CITY OF ALBUQUERQUE

RE: 1516 Summer Ave. NW
Grading and Drainage Plan
Engineer's Stamp Date: 10/06/21
Hydrology File: J13D104A

DRAINAGE AND TRANSPORTATION INFORMATION SHEET (REV 6/2018)

ENGINEER'S SEAL  DAVID SOULE P.E. #14522	1516 SUMMER AVE	DRAWN BY: WCVJ
	GRADING AND DRAINAGE PLAN	DATE: 10-01-21
 Rio Grande Engineering 1606 CENTRAL AVENUE SE SUITE 201 ALBUQUERQUE, NM 87106 (505) 872-0999	SHEET #	210210088-LAYOUT-10-01-21
		JOB # 210210088

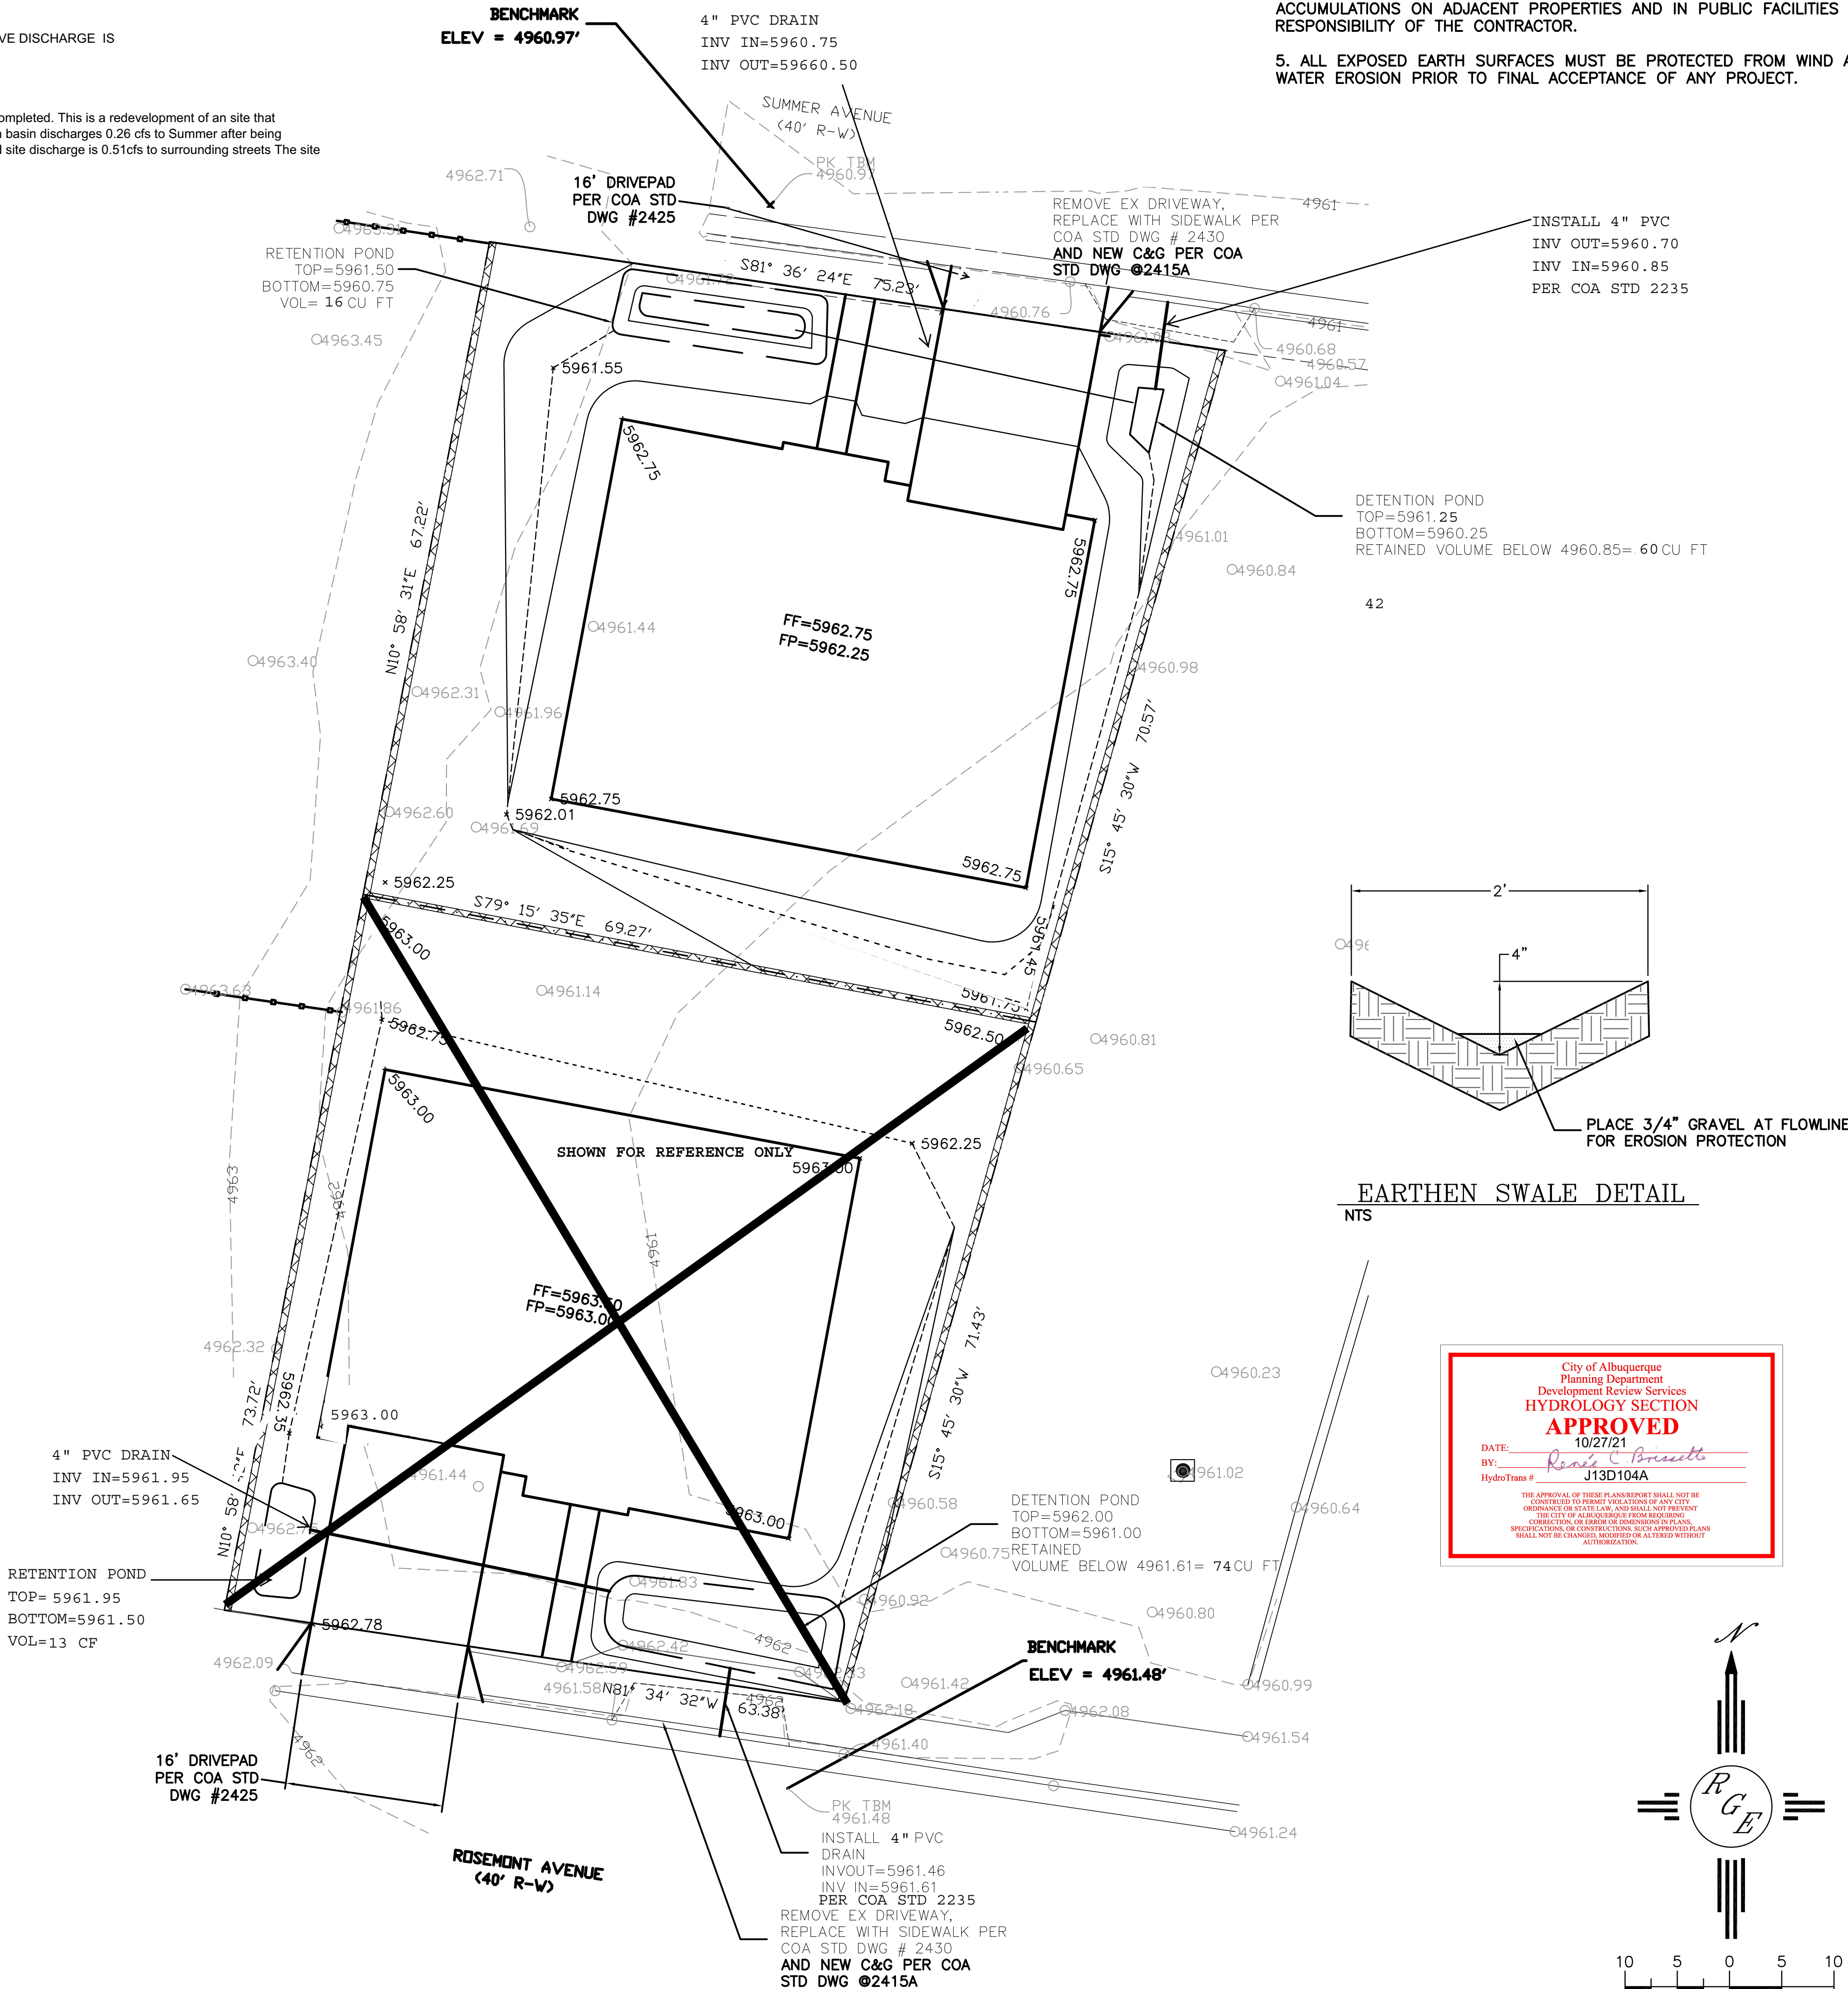
Based upon the information provided in your submittal received 10/06/2021, the Grading and Drainage Plan is approved for Building Permit and Grading Permit. Since this site appears to have need little grading for the proposed building, a pad certification is not needed for this project.

Please attach a copy of this approved plan in the construction sets for Building Permit processing along with a copy of this letter. Prior to approval in support of Permanent Release of Occupancy by Hydrology, Engineer Certification per the DPM checklist will be required.
